Project
OLD CONNAUGHT PHASE A1 LRD

The purpose of the Stormwater Impact Assessment Report is to provide details of the Storm water elements associated with the proposed development at Lands at Allies River Road, Old Connaught, Co. Dublin.

Purpose	FOR PLANNING
Title	PROPOSED STORM DRAINAGE OVERALL LAYOUT PLAN
Original Scale	1:1000 at A1 1:2000 at A3
Drawn	PM
Checked	IPR
Reviewed	IPR
Authorised	GH
Status	S4
Drawing Number	ATK-ZZ-ZZ-DR-CE-900500
Rev	P01

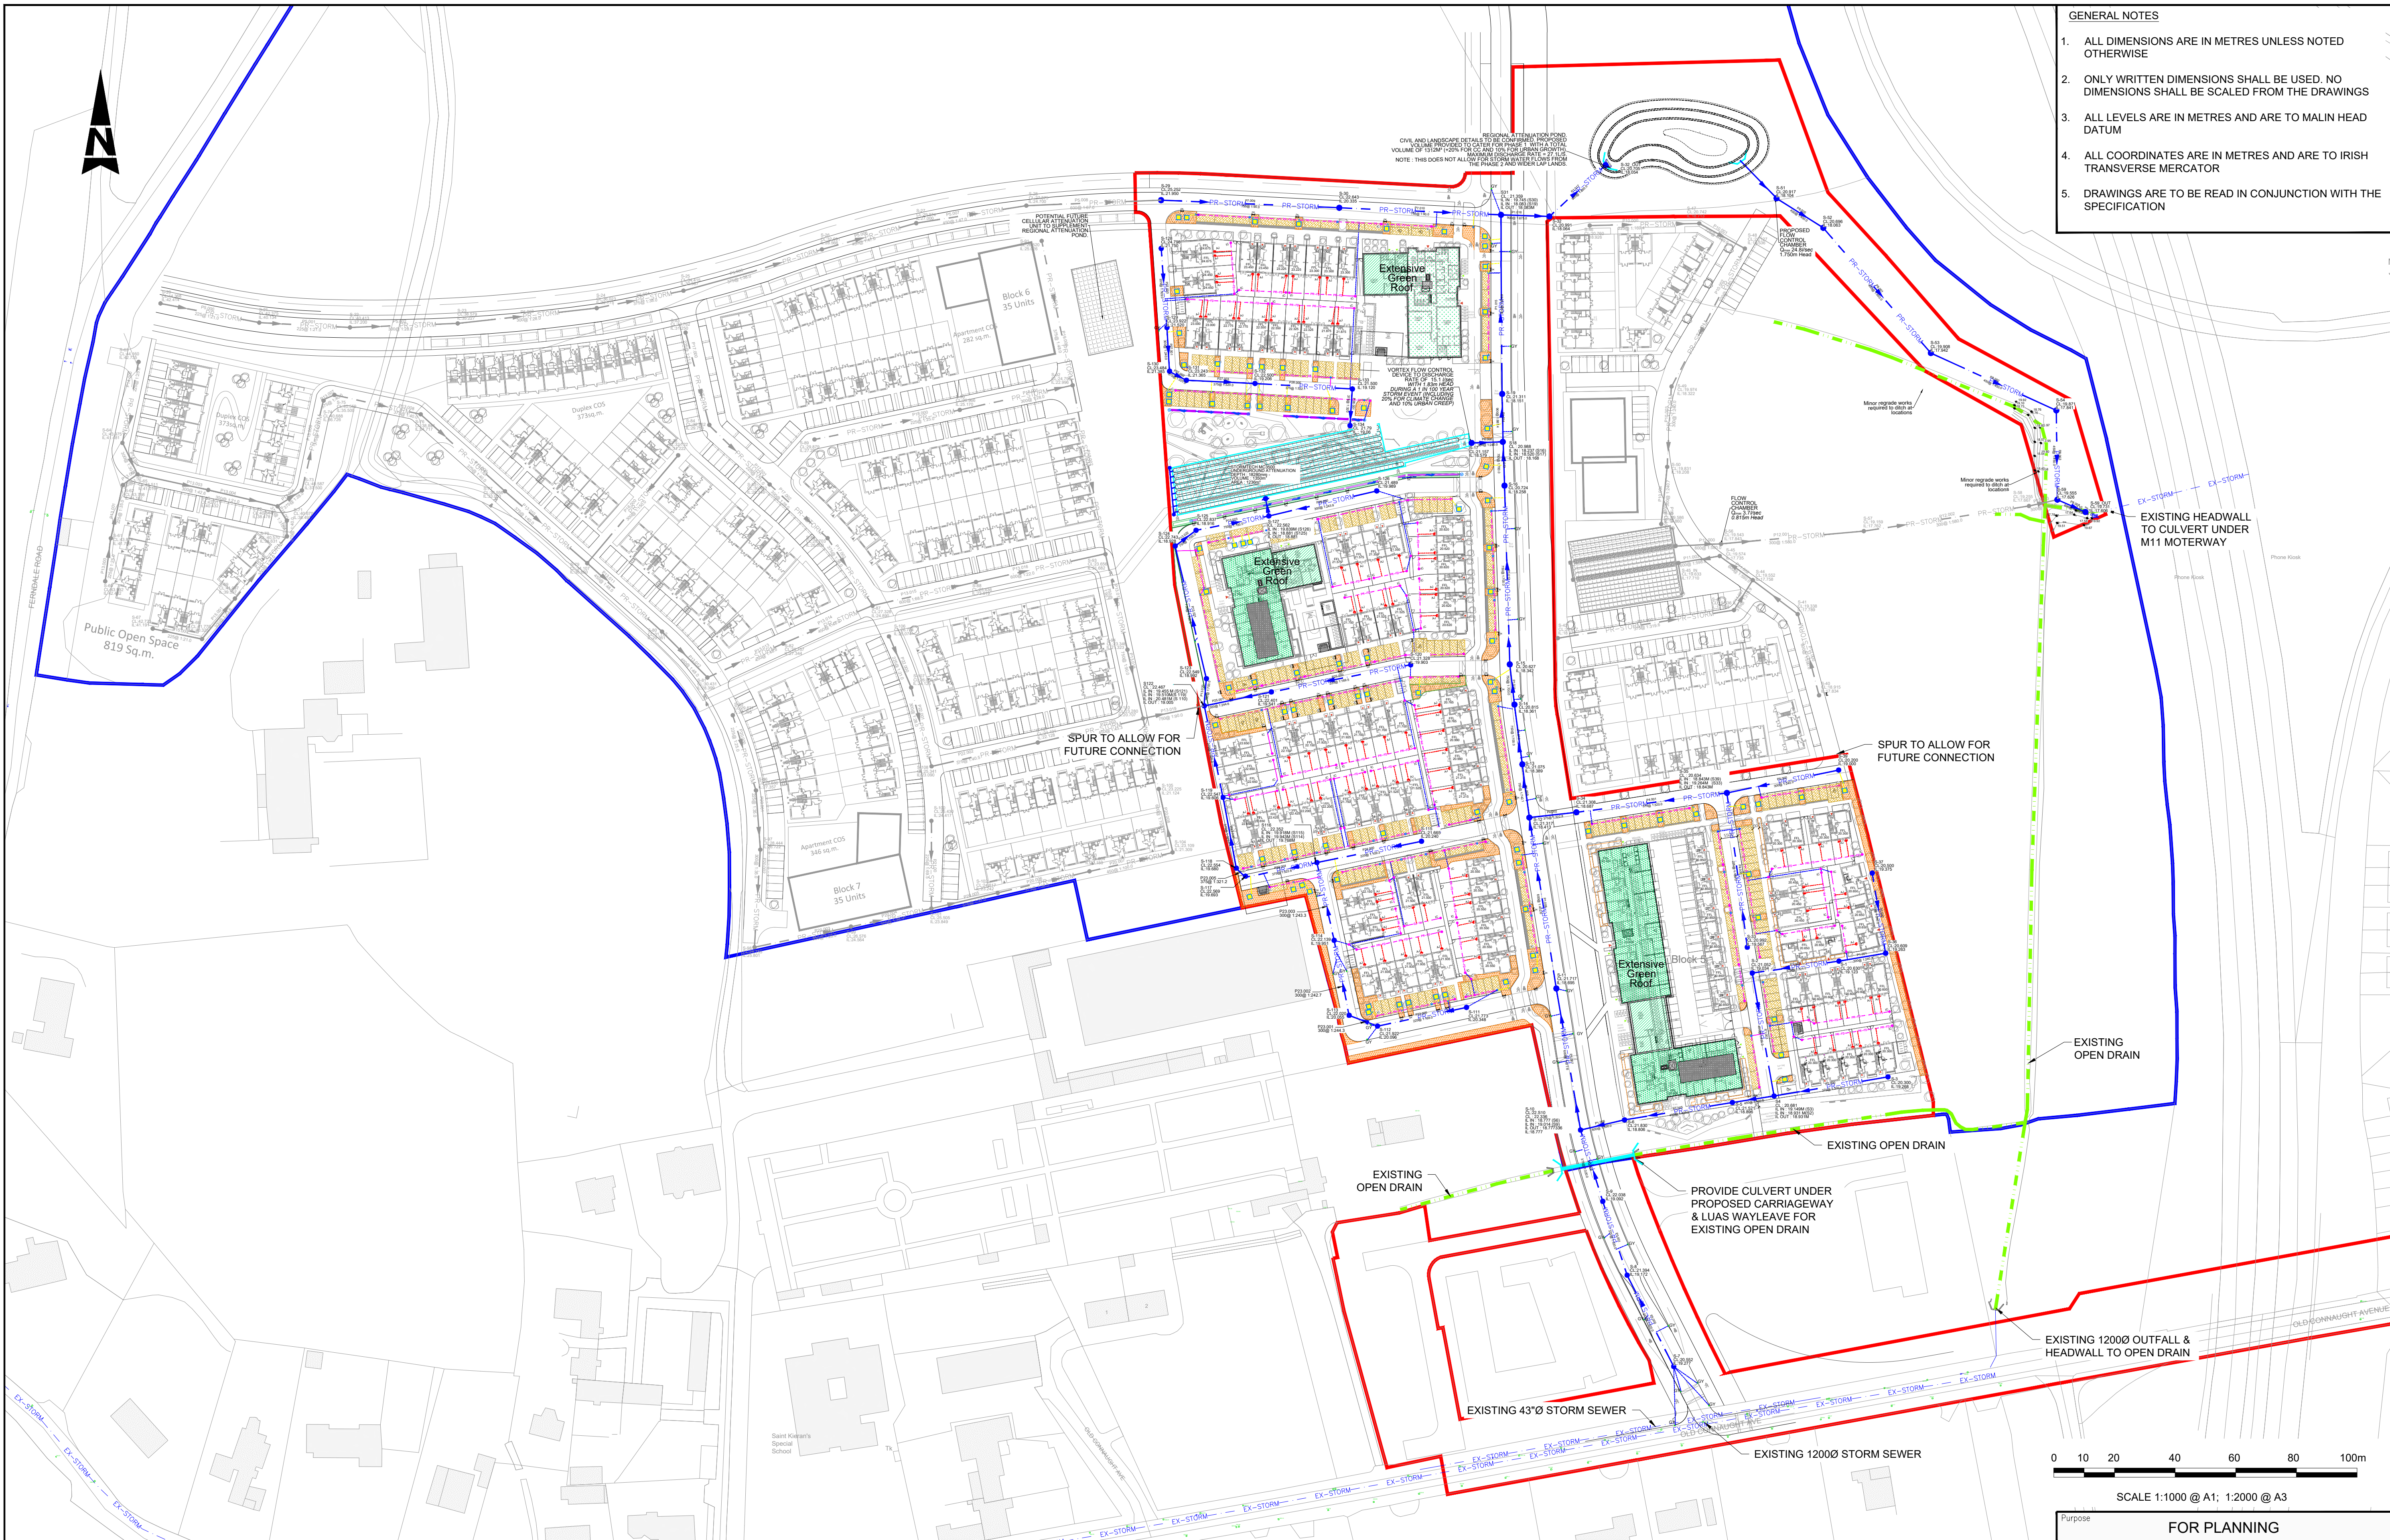
Problem: From the 'Proposed Storm Drainage Overall Plan', some tree pits appear to be standalone drainage systems with no connectivity to the surface water network. However, the Typical SuDS Details drawing indicates these features with overflow systems/outlet pipes.

Problem: It is noted on the 'Proposed Storm Drainage Overall Plan' that the Proposed Flow Control Manhole S-51 shows a controlled discharge rate (Q_{max}) of 24.8l/s. However, Table 2-1 from the SWIA Report indicates the controlled outflow as 27.1 l/s.

Problem: The 'Standard Construction Details' drawing shows manholes S40 and S41 as the inlet and outlet points of the proposed Attenuation Tank A. However, these manholes are shown as part of the future development network in the 'Proposed Storm Drainage Overall Plan'.

Problem: It is noted on the 'Proposed Storm Drainage Overall Plan' that some line types which show connections to the main line storm drainage system are not defined.

2.8	Yes	Yes	The discrepancy between the Qmax value shown on the <i>Proposed Storm Drainage Overall Plan</i> and Table 2-1 of the SWIA Report has now been resolved. Drawing ATK-ZZ-ZZ-DR-CE-900501 Proposed Storm Drainage Layout - Sheet 1 has been updated to ensure consistency across all project information.	Yes

2.9	Yes	Yes	The recommendation has been taken on board. The drawings have been updated to ensure consistency between the <i>Standard Construction Details</i> drawing and the <i>Proposed Storm Drainage Overall Plan</i> . The revised drawings ATK-ZZ-ZZ-DR-CE-900501 Proposed Storm Drainage Layout - Sheet 1 ATK-ZZ-ZZ-DR-CE-900502 Proposed Storm Drainage Layout - Sheet 2, ATK-ZZ-ZZ-DR-CE-909008 Standard Construction Details Sheet 8 reflect these updates have been submitted as part of the updated design package.	Yes

2.12	Yes	Yes	The drainage drawings have been reviewed and the undefined line types identified on the <i>Proposed Storm Drainage Overall Plan</i> have now been clarified. The legend has been updated to ensure that all line types and drainage connections are clearly defined and accurately represented. This issue has been rectified and is reflected in the updated drawings submitted as part of this revised submission package. Refer to drawings ATK-ZZ-ZZ-DR-CE-900500 Proposed Storm Drainage - Overall Layout Plan, ATK-ZZ-ZZ-DR-CE-900501 Proposed Storm Drainage Layout - Sheet 1, ATK-ZZ-ZZ-DR-CE-900502 Proposed Storm Drainage Layout - Sheet 2 for the amendments made.	Yes

TYPICAL PETROL INTERCEPTOR DETAILS

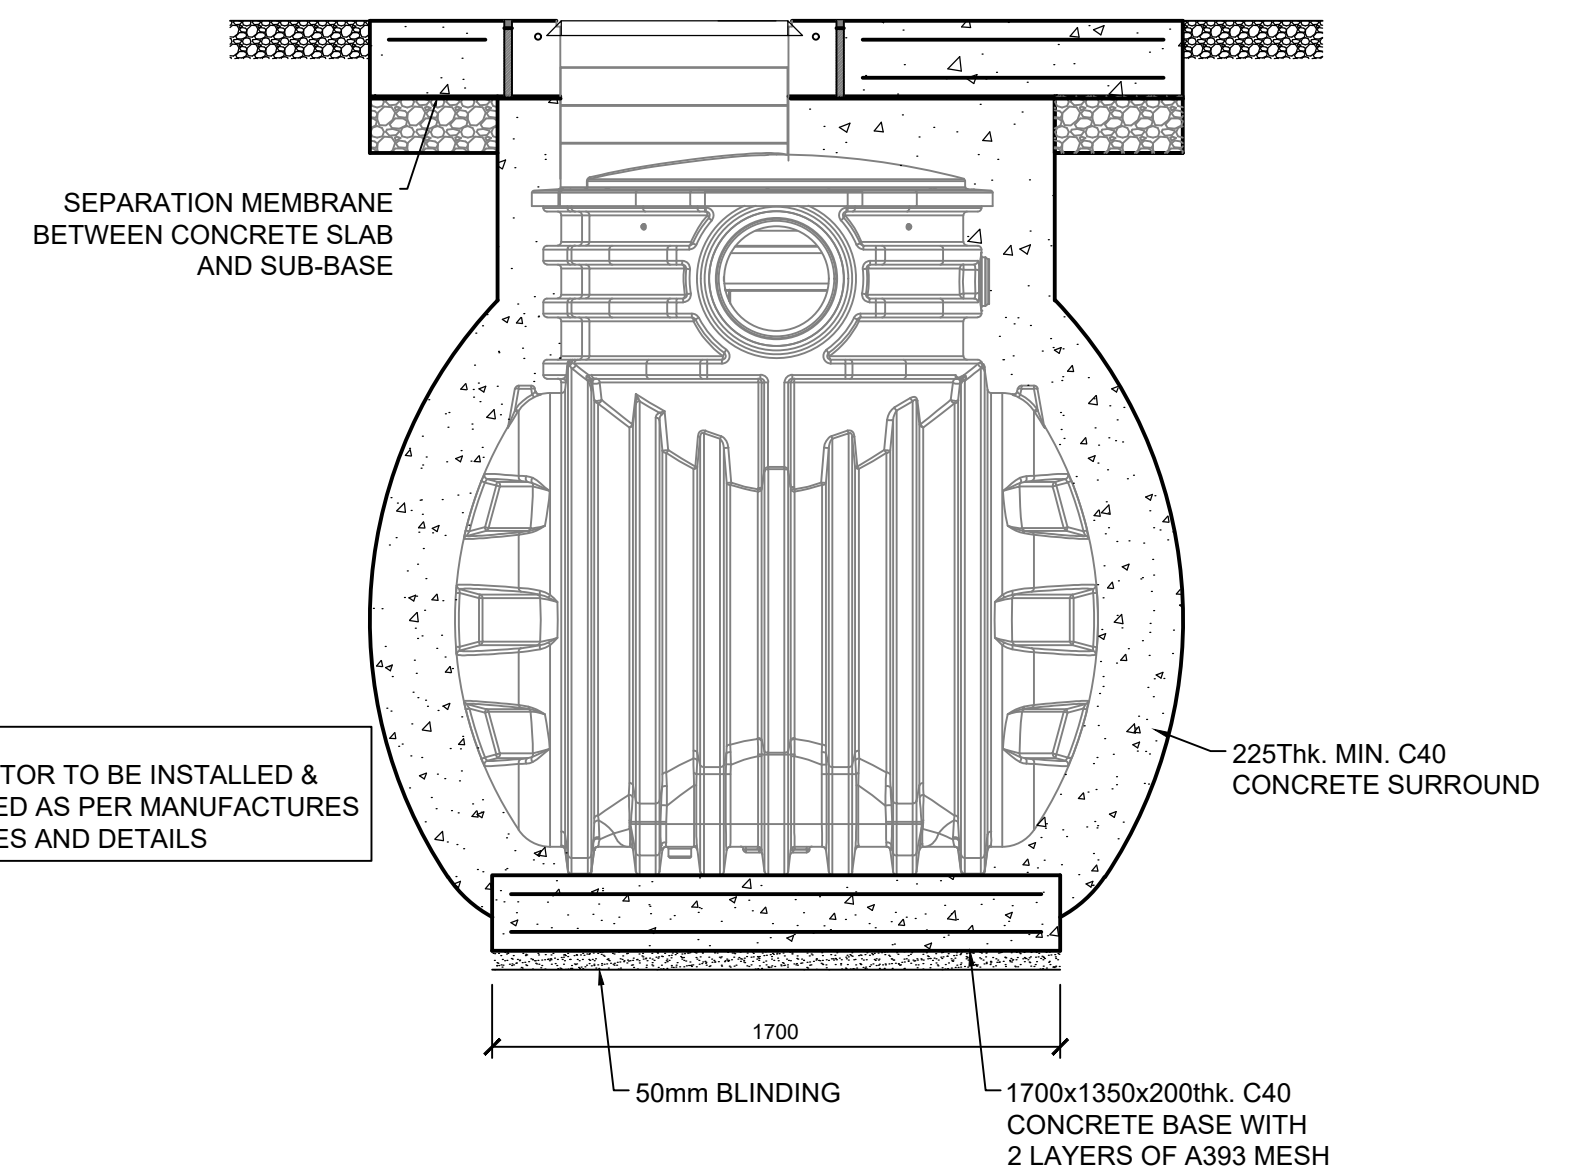
Problem: Typical details for a Petrol Interceptor have been provided in the 'Standard Construction Details' drawing. However, this feature is not indicated on the 'Proposed Storm Drainage Overall Plan'.

Recommendation: The Scheme designer to clarify and/or rectify. If the petrol Interceptor is proposed, the scheme designer is to verify that the Petrol Interceptor is sized to accommodate the contributing catchment areas and anticipated peak flow rates. Furthermore, the required drop across the Petrol Interceptor must be allowed for in the surface water long-section.

2.10	Yes	Yes	Comment noted. The recommendation has been accepted. There is no Petrol Interceptor proposed as part of the surface water drainage scheme. Accordingly, the Petrol Interceptor detail has been removed from the ATK-ZZ-ZZ-DR-CE-909002 <i>Standard Construction Details Sheet 2</i> drawing to ensure consistency with the <i>Proposed Storm Drainage Overall Plan</i> .	Yes
